SUBJECT: REQUEST FOR ADDITIONAL INFORMATION ON PROPOSED ALTERNATE BWR
FEEDWATER NOZZLE INSPECTION REQUIREMENTS

The staff is reviewing the BWR Owners' Group submittal, "Alternate BWR Feedwater Nozzle Inspection Requirements," dated October 30, 1996. This submittal provided recommendations for feedwater nozzle inspections that are intended as an alternative to those contained in NUREG-0619 based, in part, on advances made in ultrasonic techniques since 1980.

BWROG PROPOSED ALTERNATIVE TO NUREG-0619
REQUEST FOR ADDITIONAL INFORMATION

Figure 1. Analysis of GE Figure 4 data (approximate)

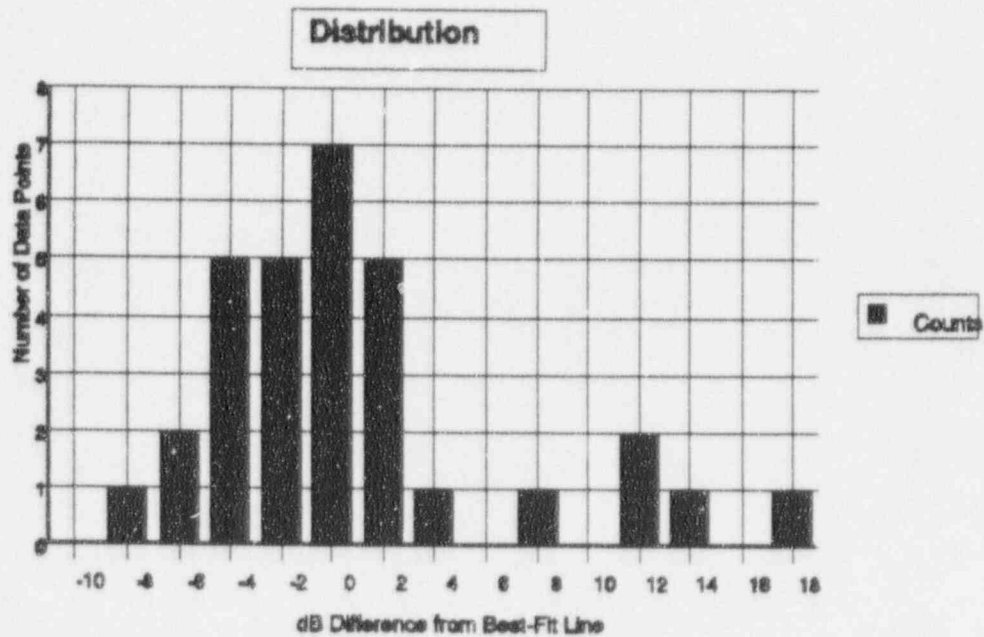
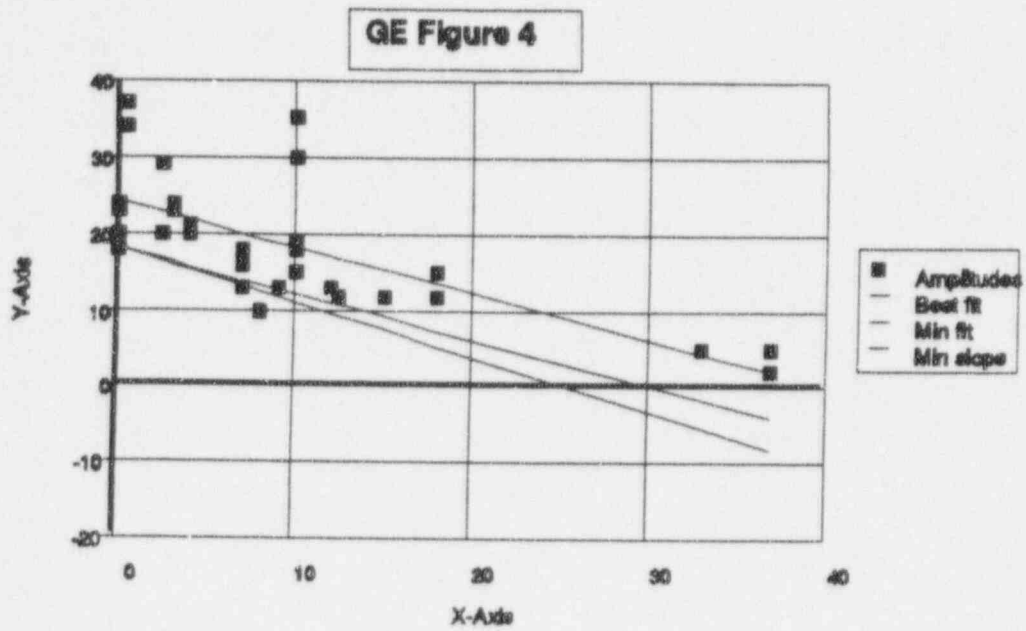
Figure 1 of this Attachment (which contains the pair of graphs labeled "GE Figure 4" and "Distribution") shows some simple statistics that can be applied to the data of Figure 4 in GE-NE-C3100016-02. In the scatter graph in the upper part of Figure 1, the best-fit line has been shown, but then the lowest-amplitude fit line is also shown (subtracting the standard error of Y estimate from the regression output) and also the lowest-amplitude, minimum-slope fit

line (subtracting the standard error of coefficient from the slope of the best-fit line). The bar graph in the lower part of Figure 1 shows that the data are not normally distributed, which gives further reason to be conservative in interpretation.

- a. Provide an analysis on the causes of scatter in the data (for example "alpha" insonification angle, frequency, transducer diameter, and bandwidth).
- b. Provide additional data, if available, to improve statistics or explain scatter.
- c. Provide a statistically defensible methodology for determining the maximum allowable misorientation angle.

Figure 2. Exponential fit to the data of GE Figure 4 (approximate)

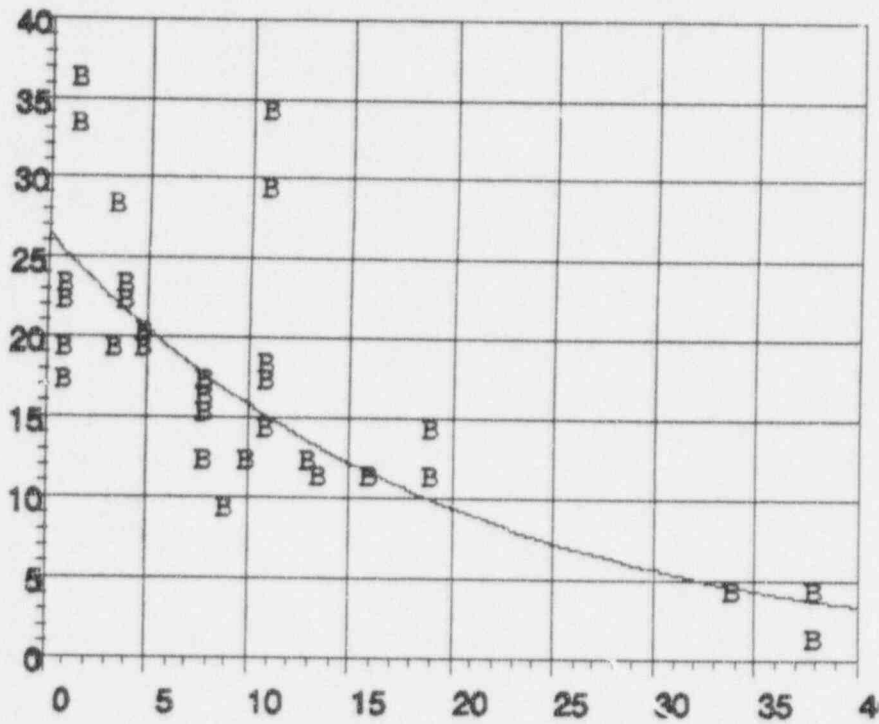
It is not clear why there should be a linear relationship between misorientation and log-amplitude, as implied by the use of a linear best-fit curve in Figures 4-6 of GE-NE-C3100016-02. For example, fitting a negative exponential curve to the data improves the R-squared from 0.5 to 0.7 (Figure 2 to this Attachment). This is not to suggest that the amplitude is actually a double power function, but just to emphasize that more work is needed to give either theoretical or experimental assurance that certain large misorientations will not result in underinspection. According to Kratukramer (*Ultrasonic Testing of Materials*, 1983, p.66) the amplitude as a function of angle for a circular object is given by a Bessel function composed with a sine function. For long cracks, minima can be expected for certain misorientation angles, which means that, for example, for a certain setup, misorientation angles of 20 degrees and 30 degrees might both give adequate reflections, while a misorientation of 25 degrees might give no reflection at all. In addition, as the misorientation angle grows large, the diffraction is probably from the edge of the crack, and not from the crack face, in which case misorientation has very little effect, since crack edges diffract in nearly cylindrical or spherical patterns. This may be one reason that the negative exponential appears to fit the data better, as it may be that for very large misorientations, it is the edge of the defect that is being detected. Discuss the theoretical treatment of the misorientation angle and provide a POD (which should be something on the order of 90/95) for misoriented insonifications that do not exceed the maximum allowable misorientation angle. The treatment of this does not need to be with specific reference to nozzle geometries, but any inspection using comparable essential ultrasonic variables.

Figure 3. Direction of UT Transducer over Grindout Flaw

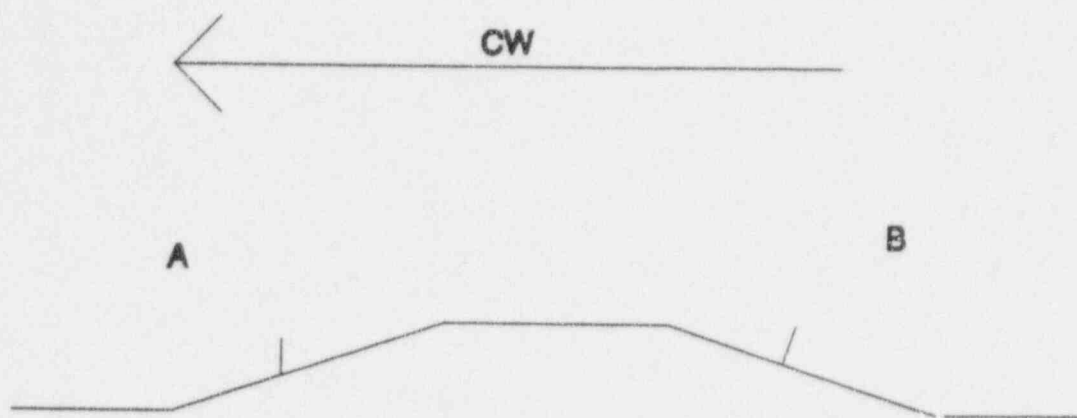
Apart from the question of noise, the geometry of the grindout can affect the reflected signals (although not the tip-diffracted signals). If the crack propagates normal to the nozzle surface (A in Figure 3 of this Attachment),

then the corner trap amplitude is reduced from both clockwise (CW) and counter clockwise (CCW) directions. If the crack propagates normal to the grindout surface (B), then the amplitude may be reduced from the CW direction but maintained or enhanced from the CCW direction.

- a. Provide and discuss data or fracture mechanics analysis to indicate which situation is more likely to occur, and whether this is substantially different from regions without a grindout.
- b. Discuss estimates of the reduction in indication amplitude.
